**COMMITTEE OF ADJUSTMENT**

**NOTICE OF PUBLIC HEARING**  
**Minor Variance**

<b>APPLICATION NO.:</b>	<b>HM/A-22:160</b>	<b>SUBJECT PROPERTY:</b>	57 RYMAL RD W, HAMILTON
<b>ZONE:</b>	“C5, 318, T8” (Mixed Use Medium Density)	<b>ZONING BY-LAW:</b>	Zoning By-law City of Hamilton 05-200, as Amended

**HAMILTON VOLVO ADDITION**  
 57 RYMAL RD. W.  
 HAMILTON, ON

FILE NUMBER: SPA-19-  
 DATE: SPA-19-  
**SP1.0**

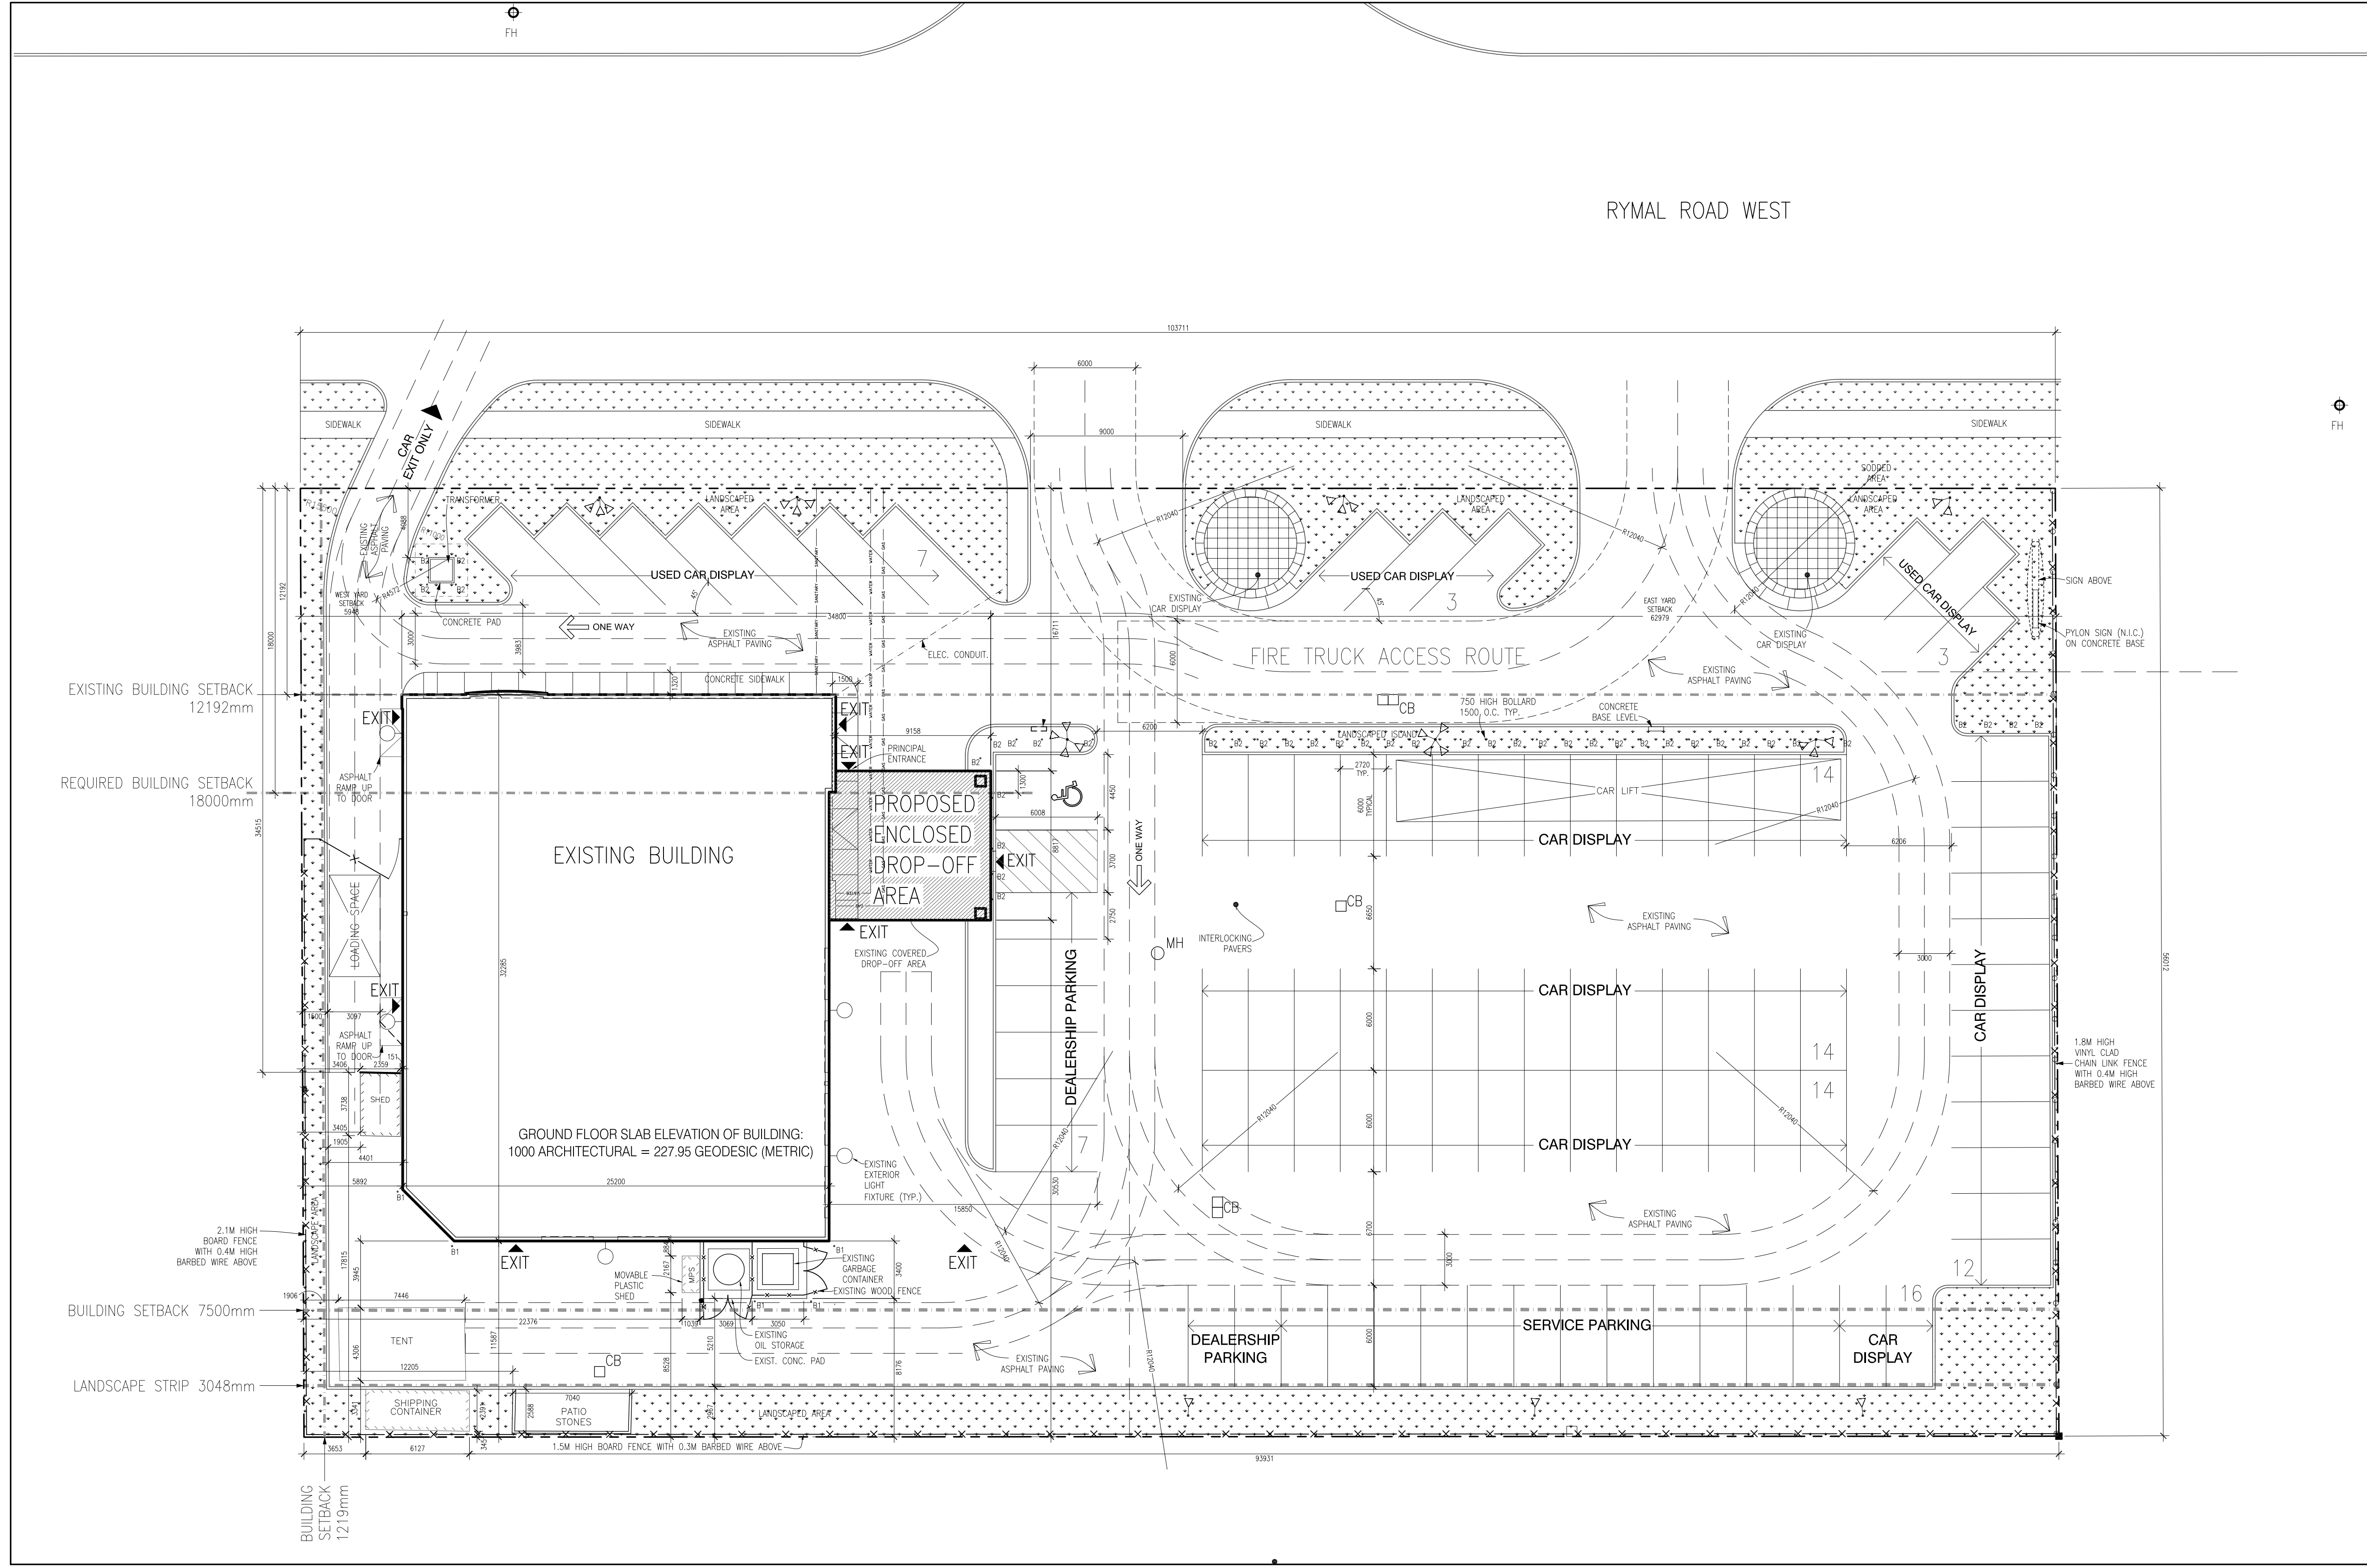
1. Please revise the Site Plan to show the total number of service bays on the Site Plan as this information is necessary in order to determine the total number of required number of parking spaces.  
**Please see the revised on drawing SP1.0 - Site Plan attached. Parking for the service bays has been designated on the plan. Parking statistics have also been amended.**

Further, please specifically identify the exact parking spaces intended for the motor vehicle dealership which are not meant for car display.  
**Parking spots have been designated for the motor vehicle dealership.**

2. Please revise the Site Plan to identify each of the spaces for outdoor display as it is unclear which are intended for parking spaces as required for a Motor Vehicle Dealership and those spaces and which are for outdoor display.  
**Outdoor display spots have been designated on the revised on drawing SP1.0 - Site Plan.**

3. Please revise the Site Plan to show the width of the "landscaped area" along the rear lot line. Please be advised that a 1.5m wide planting strip is required along the southerly rear lot line. A planting strip is defined as:

4. Please confirm the parking space sizes as there are different sizes shown on the Site Plan vs the Legend. The Site Plan indicates a typical width of 2.72m x 6.0m; however, the Legend indicates "Existing Parking Space (2600mm x 5500m) and "Proposed Parking Space (3000m x 5800mm). The Site Plan does not identify the "existing" and "proposed" spaces. If the space sizes in the Legend are incorrect, they should be removed from the Legend.  
**Please note that the legend has been amended to be consistent with the plan.**

5. Please revise the Site Plan to show the width of the one-way aisle/driveway width between the existing building and the 7 space used car display and the one-way "car only exit" driveway at the west side of the lot.

6. Please confirm if a visual barrier, including its height, has been provided along the southerly rear lot line. It appears to be chain link fence which is not considered a visual barrier.

**The width of the "landscaped area" has been shown on the revised drawing SP1.0 – Site Plan. Please note that we are requesting an additional relief to permit the PATIO STONE (permeable paving) area located along the southerly required 1.5 m Landscaped Area. Reason: During the history of the dealership it was found that during nice weather the employees found the need of an outdoor eating area on site. This area was chosen and designated so that it would not be visible from the front of the building. Please see revised Item 4 attached.**

**Please note that there are no spaces fitting the small car description.**

**Please note that the dimension has been shown on the revised plan. The angle of the angled parking has been shown also. The one-way aisle/driveway for the angled parking does not meet the minimum 4.5 m width for 45 degree angled parking. As this is an existing condition since the original Site Plan Approval please advise if relief is required for the reduced width.**

**Please note that the existing fence is a 1.5 m high board fence.**
